3 August 2016

**INFORMAL REFERRAL COMMENTS – DA 090/M004/16
179 GREENHILL ROAD (and 1 GEORGE STREET) PARKSIDE**

Proposed 9:00am 22 June

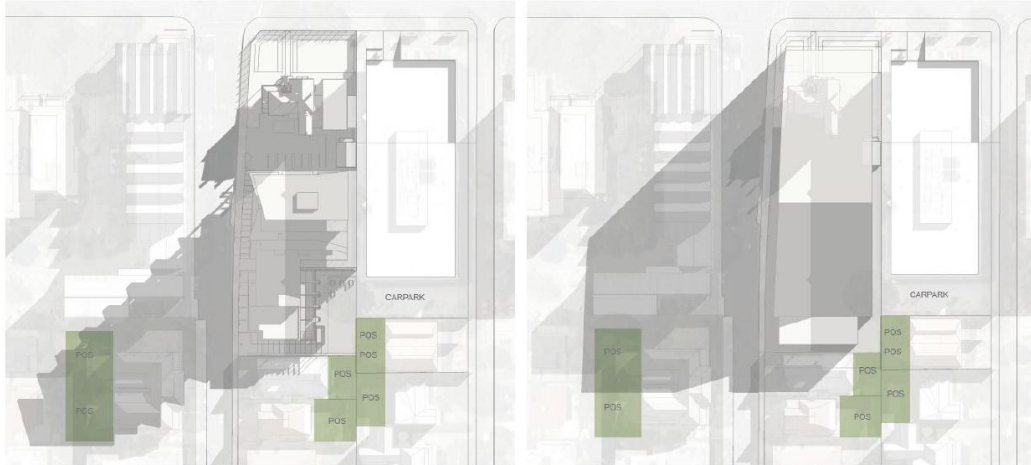
- While this construction over 1 George Street avoids undue shadow to 3 George Street, the 10 storey tower is 15 metres closer than expected to 3 George pursuant to the resolved policy and does pose increased over-shadowing to residential properties to the south east and south west.

- The size of the mid-floor levels should be increased to accommodate an extra dwelling so a full mid-level may be removed thereby reducing the overall height and particularly encroachment into the Building Envelope to the benefit of better policy conformity and impacts to residential neighbours.
